# SERVICE LETTER SL31 66-12020

1. **Service Letter No.:** SL31 66-12020
2. **Release Date:** August 29, 2017
3. **Reason for Change:** Dimensions between key areas of floats
4. **Part/Assembly No.:** Drawing 66-12020
5. **Float Model Affected:** 6650
6. **Disposition of Product in Field:** Informational Only
7. **Approval:** All information provided is in accordance with approved data.
8. **Corrective Action:** (Informational Only)
9. **Time Required:** N/A
10. **Payments:** N/A

**Figure 1: Shim Location 66-12020**

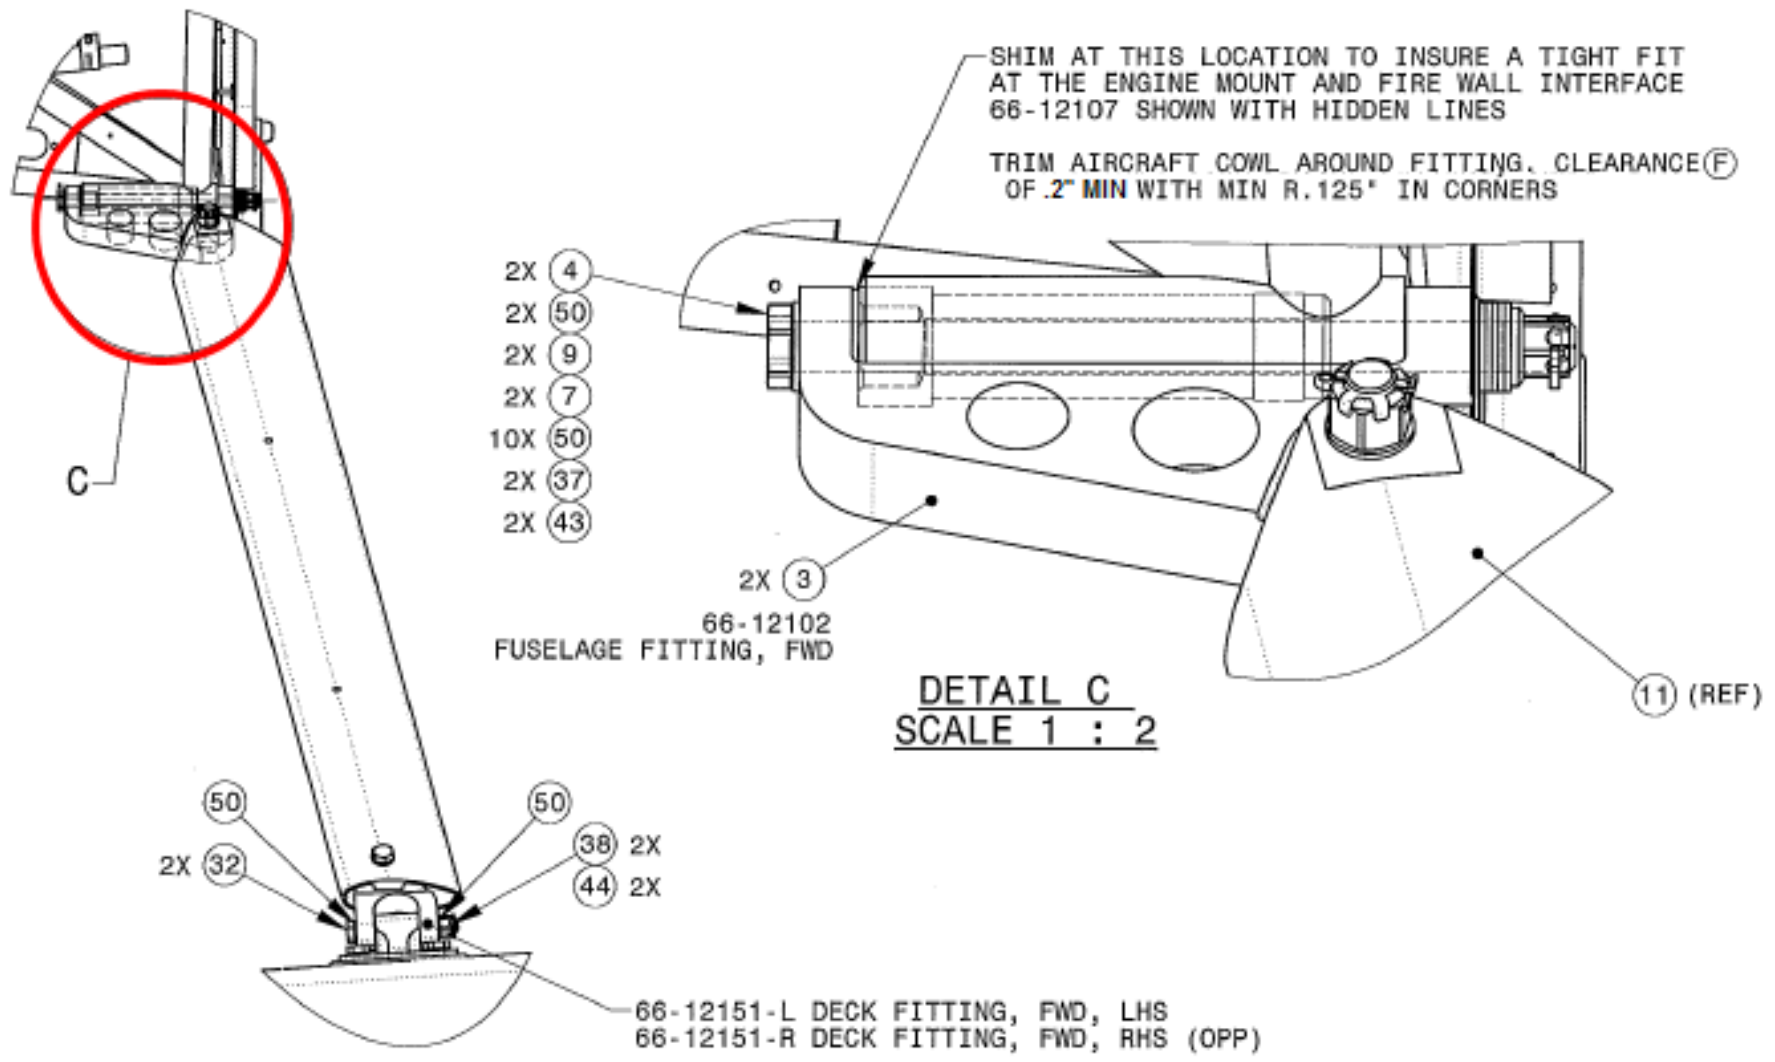
1. There should be a minimum .2" opening around the fitting including the fuselage flange ahead of the firewall. See Figure 1 below.
2. There is some rotational movement on the front fitting. This gap should be opened to keep this from happening.

3. Any damage can be cleaned up as there is nothing structural in this area on the flange of metal or cowling.
4. Rotations for takeoff (VR1) should be no higher than 53 KIAS.
